**SECTION 00 9111
ADDENDUM NUMBER ONE**

DATE: JULY 28, 2025

PROJECT: IOWA STATE FAIR – SWINE-CATTLE BARN UPDATES – PHASE 1

ARCHITECT: KEFFER/OVERTON ARCHITECTS

1/4" = 1'-0"

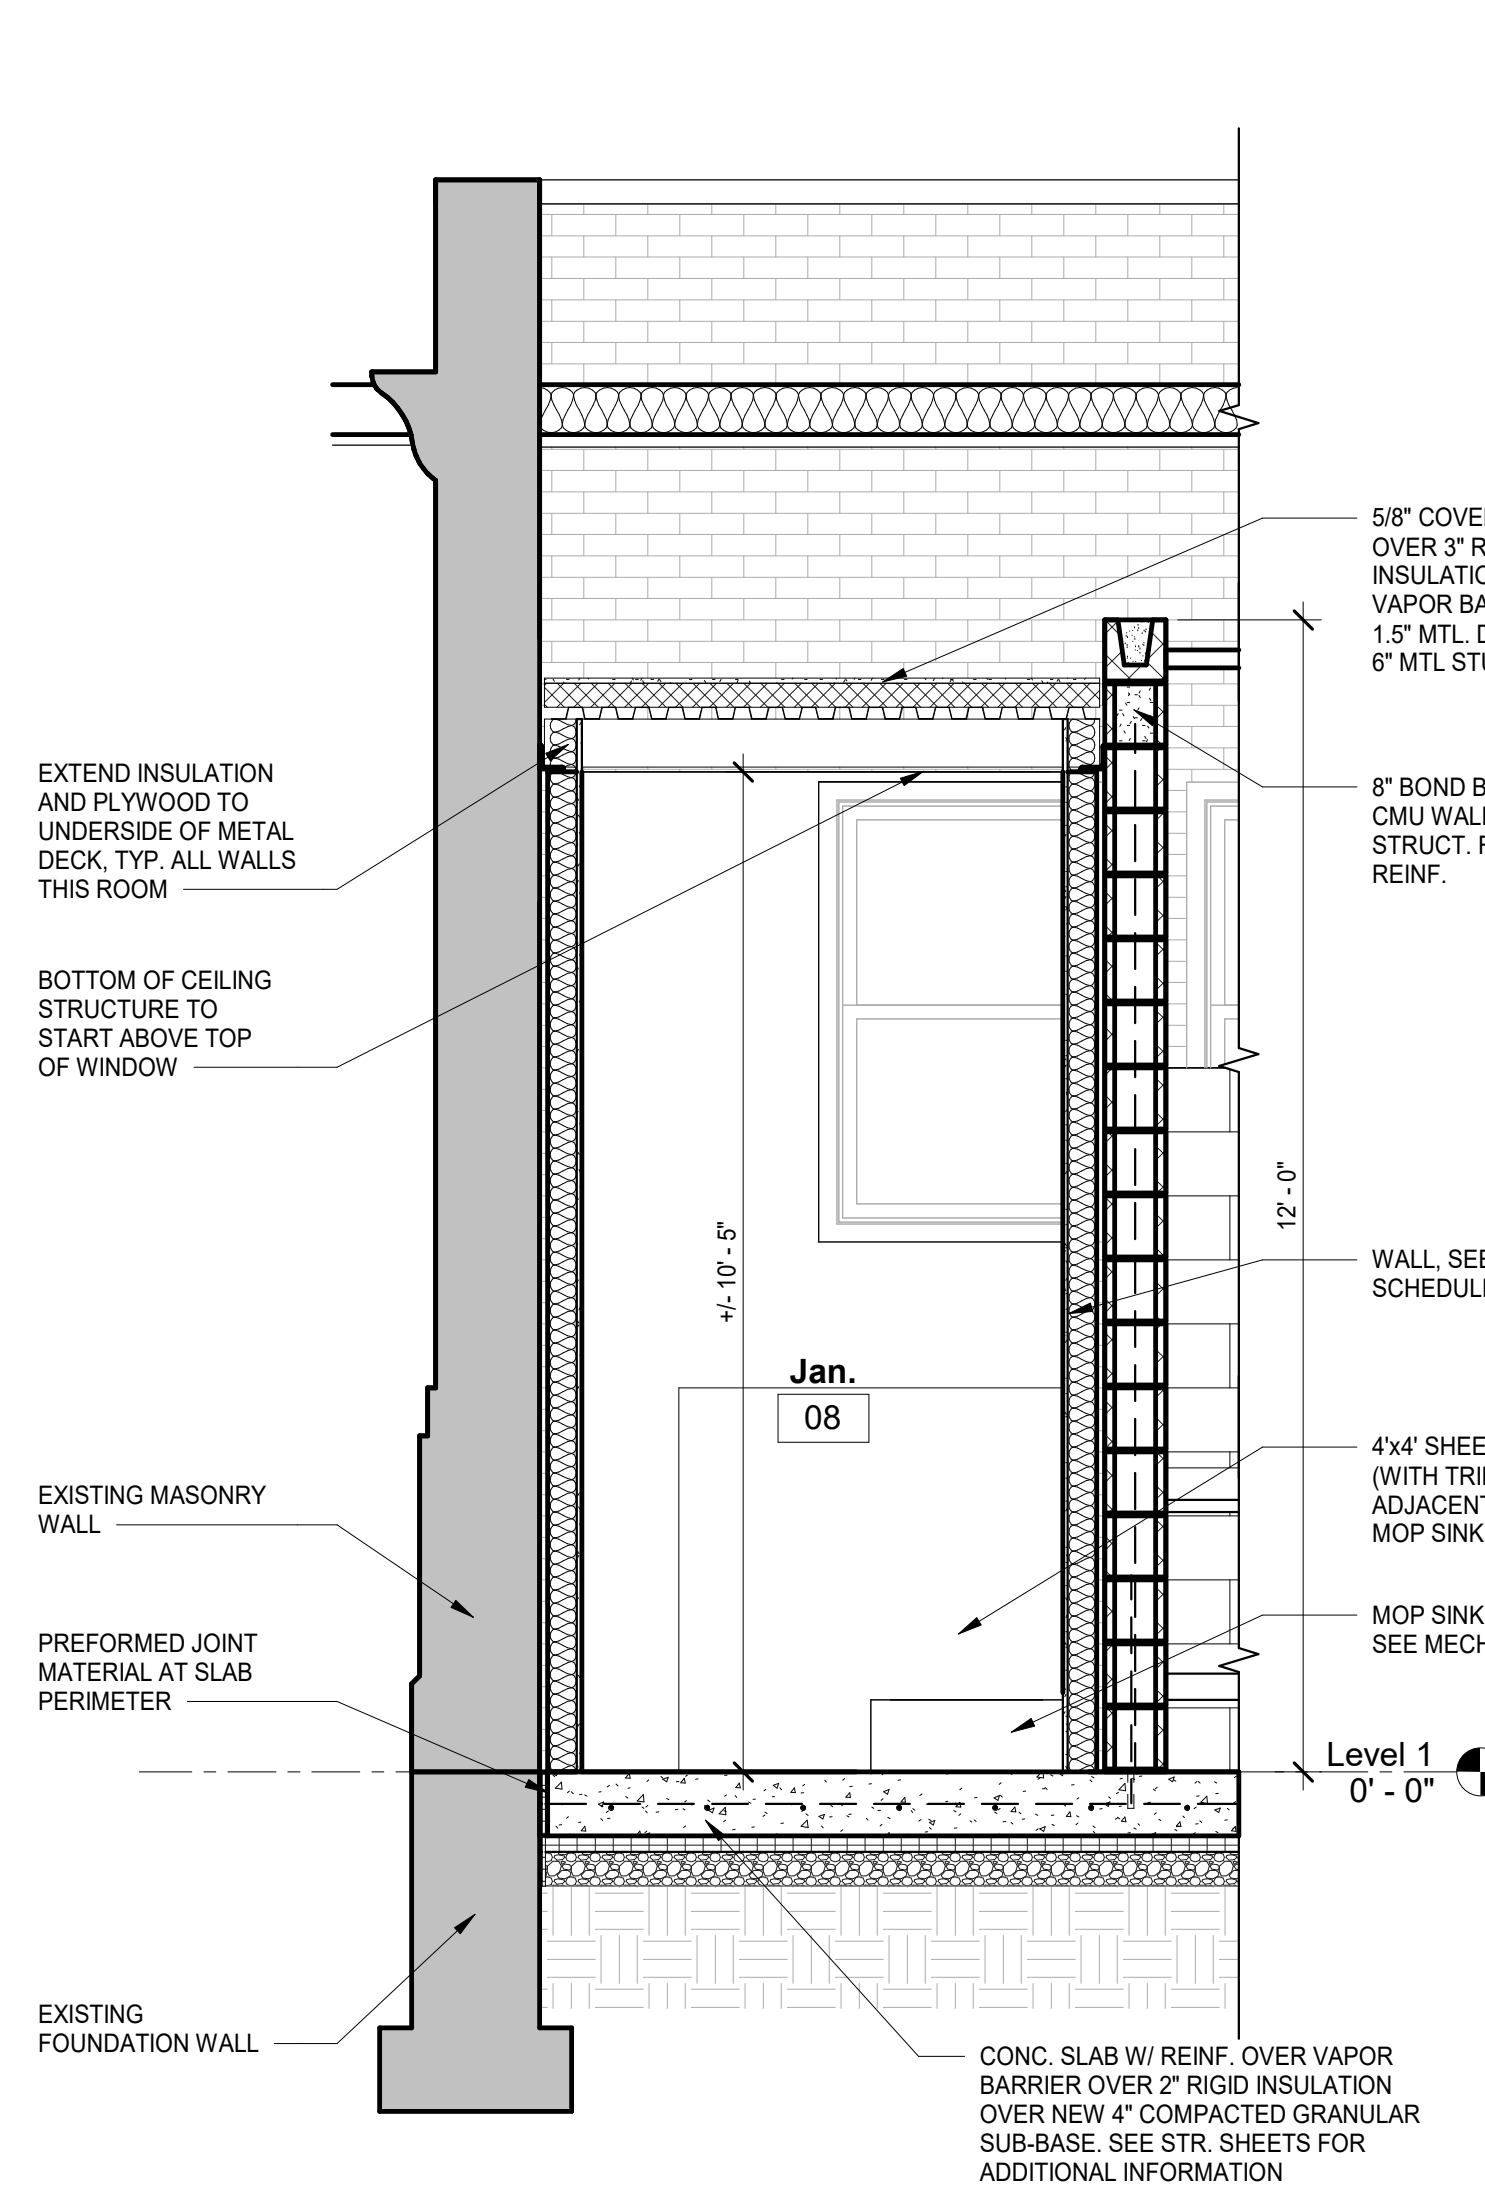
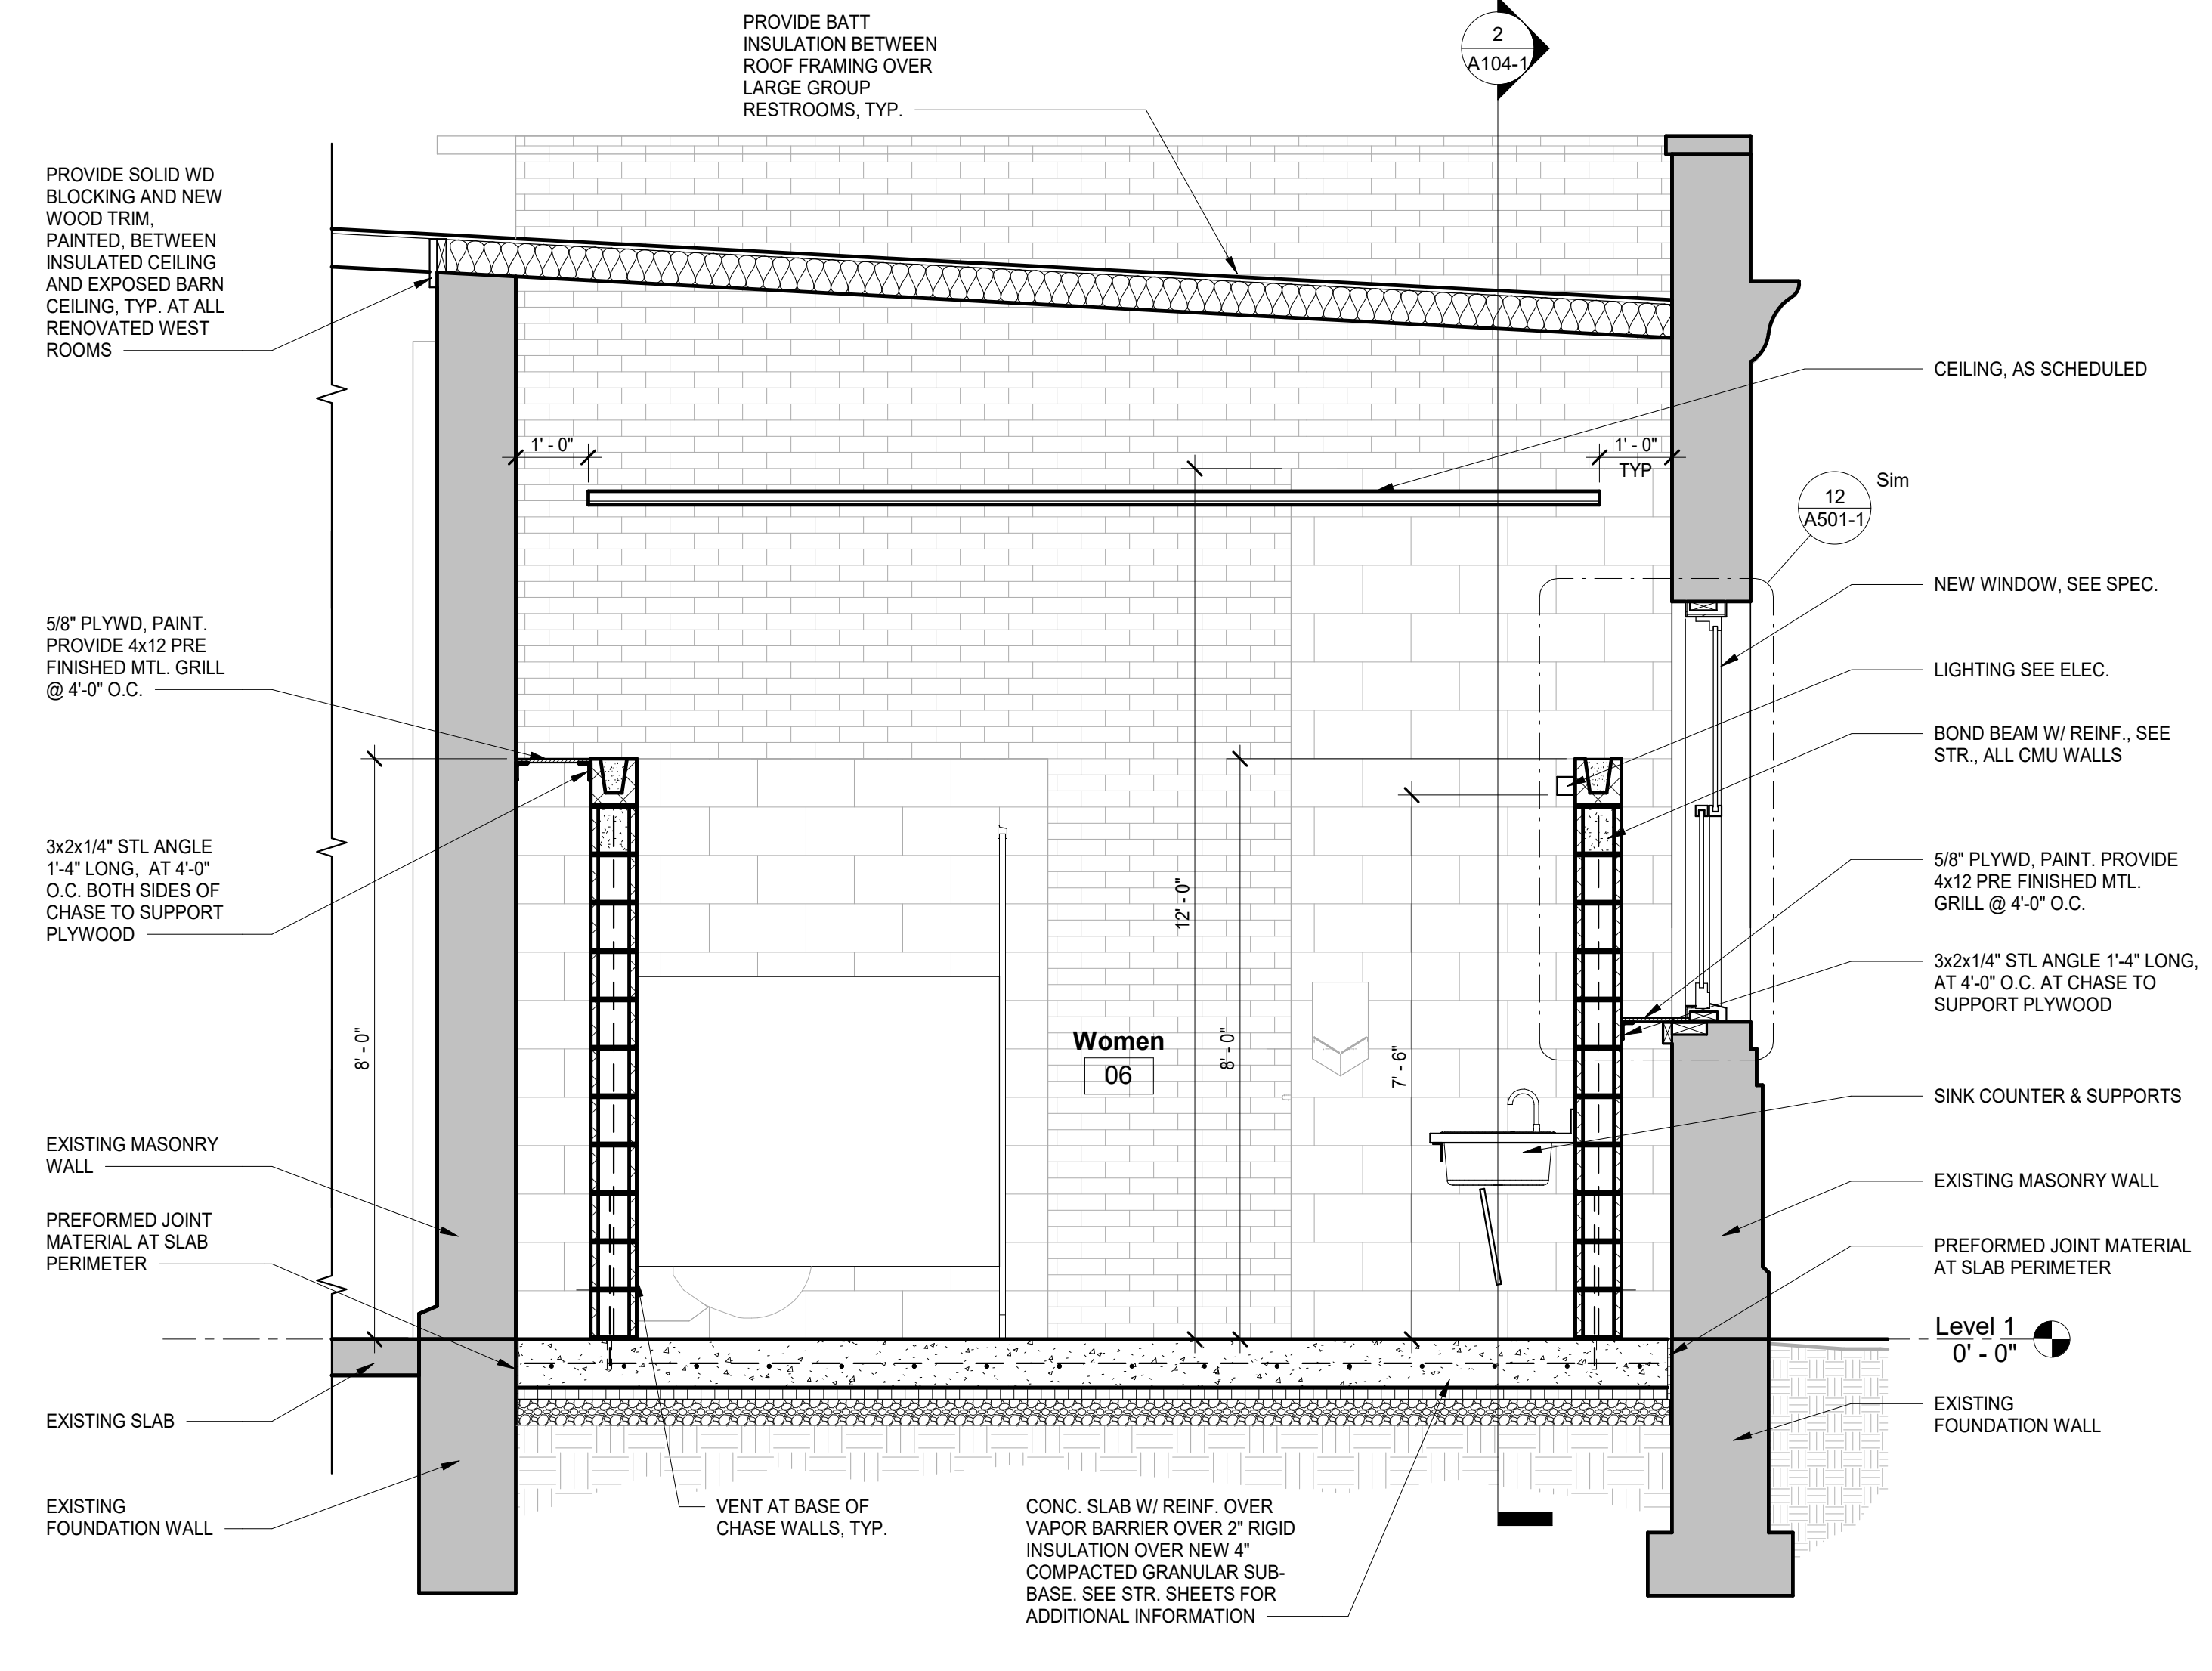
- B. SHEET A102-1 – ENLARGED RESTROOM PLANS (Refer to revised sheet.)
 - 1. Detail 2. Phase 1 – Enlarged Demo Floor Plan. Replace this floor plan in its entirety as shown on Attachment A102-1.

- 2. Detail 3. Modify extents of concrete floor slab between rooms as shown on Attachment A102-1.
 - 3. Detail 4. Add note pointing to column in Men's Room 11 as shown on Attachment A102-1.

A104-1

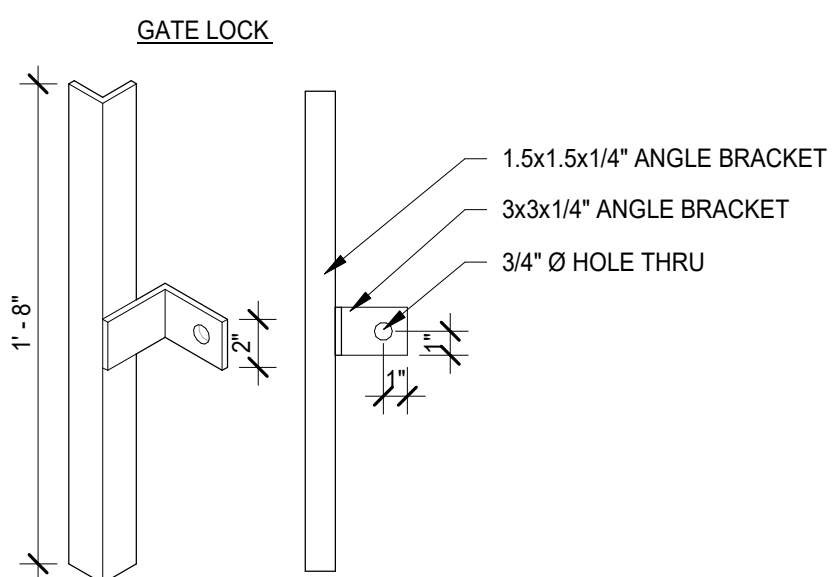
- C. SHEET A104-1 – WALL SECTIONS (Refer to revised sheet.)
 - 1. North-South Building Section Detail 4. Modify wall section as shown on Attachment A104-1.
